ENGINEERING CHANGE NOTICE

Proj. ECN B-714-158

5. Project Title/No./Work Order No.
GROUTED WASTE DISPOSAL FACILITIES
B-714/ER8007

6. Bldg./Sys./Fac. No.
218-E-16

REF DWG H-2-77639 SH 1

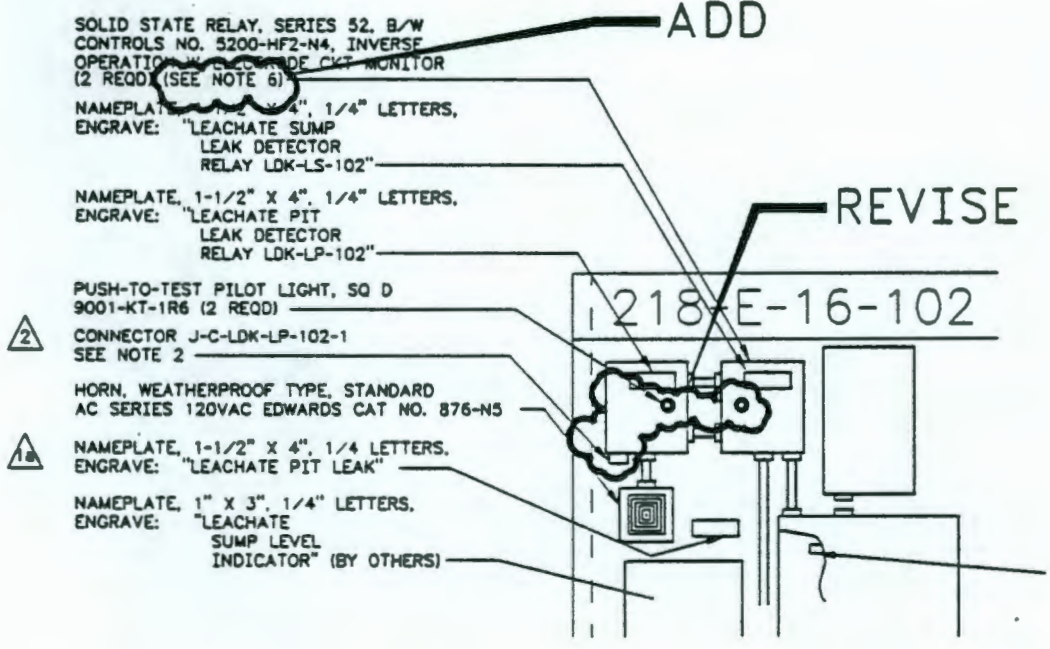
- 1) H-2-77639 Sh 1, Rev 2
 A) (Z E6-F8): Modify as shown on page 4 of this ECN.
 B) (Z B1-2): Add Note 6 as follows:

6. POSITION RELAY INSIDE ENCLOSURE TO PROVIDE SPACE FOR THE PILOT LIGHT CONTACT BLOCK. UTILIZE A 14 GA MIN STEEL PLATE FASTENED TO THE INSIDE OF THE ENCLOSURE USING THE MOUNTING NUTS PROVIDED BY THE RELAY MANUFACTURER. SECURE THE RELAY TO THE MOUNTING PLATE BY USE OF (3) MACHINE SCREWS.

REF DWG H-2-77639 SH 2

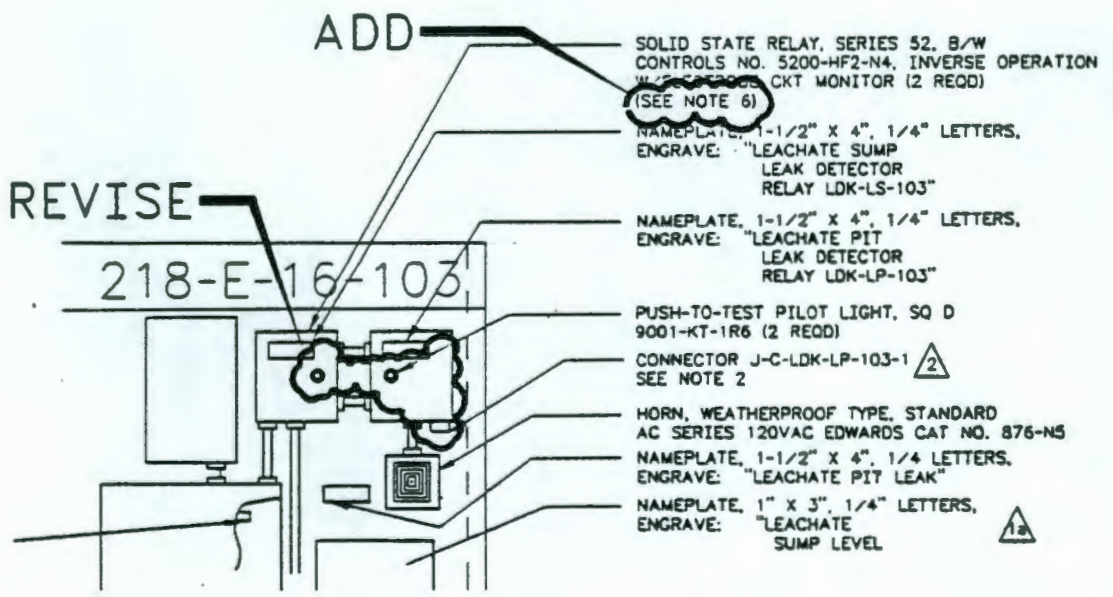
- 2) H-2-77639 Sh 2, Rev 2
(Z E5-F6): Modify as shown on page 4 of this ECN.
- 3) H-2-77649 Sh 2, Rev 0
 A) (Z A5) Detail 3: Change "Polyurethane" to "PVC"
 B) (Z B3) Detail 3: Add WITH TYPE "S" BACKSHELL after PV-76L22-55PL
- 4) H-2-78505 Sh 1, Rev 2
 A) (Z E6-F8): Modify as shown on page 5 of this ECN.
 B) (Z B1-2): Add Note 6 as shown in Item 1B above.
- 5) H-2-78505 Sh 2, Rev 2
(Z E5-F6) Modify as shown on page 5 of this ECN.
